ENGINE - AIR - ADDITION OF DETUNING HOLES ON THE ACC FRONT DUCT - CATEGORY CODE 6 -
MOD.ENG-75-0045

V2500–ENG–75–0045

SERVICE BULLETIN

Replacement of ACC Front Duct
Fig.1

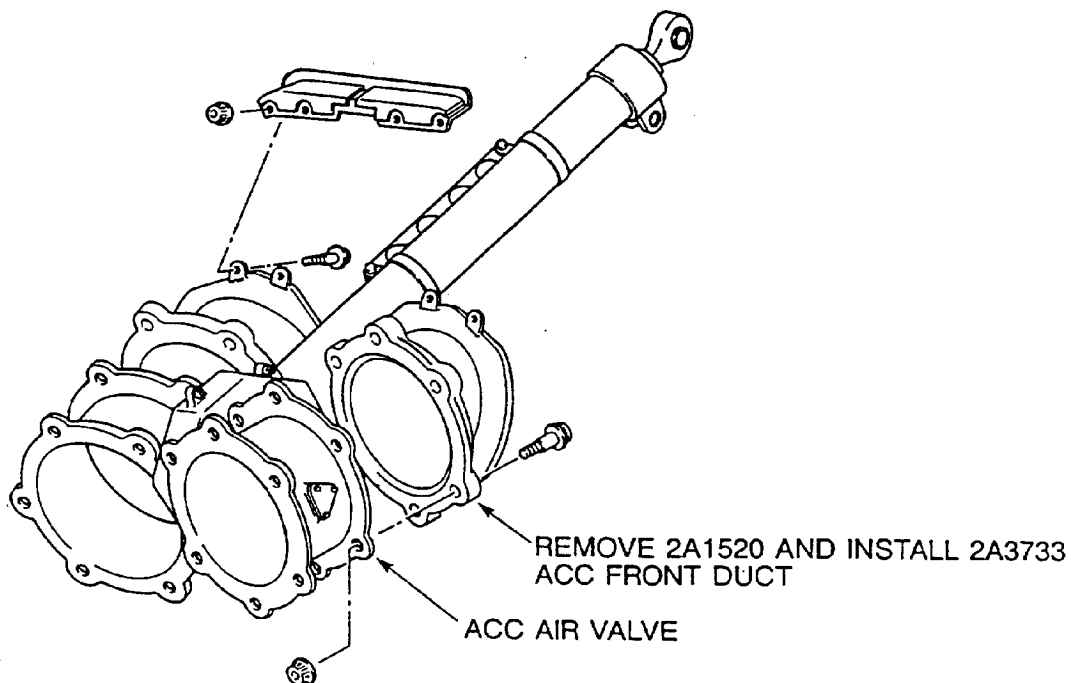
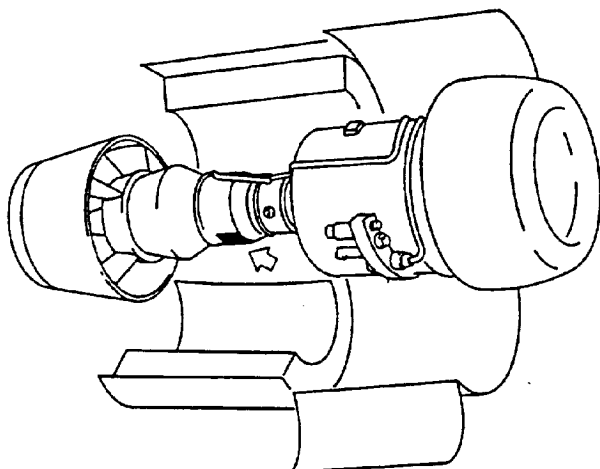
V2500-D5 engines do not have detuning holes on the ACC inlet ducts.

Existing V2500 engine models have detuning holes on the ACC duct.
Addition of the holes has demonstrated reduction of accoustic resonance level and improved durability of ACC system parts.

To add holes to the ACC Front Duct.

(a) 2A3733 ACC Front Duct supersedes 2A1520 ACC Front Duct.

- (1) When you Install the ACC Front Duct by the approved procedure in the Reference (3), Chapter/Section 72-00-40, Installation-10, install 2A3733 ACC Front Duct instead of 2A1520 ACC Front Duct.
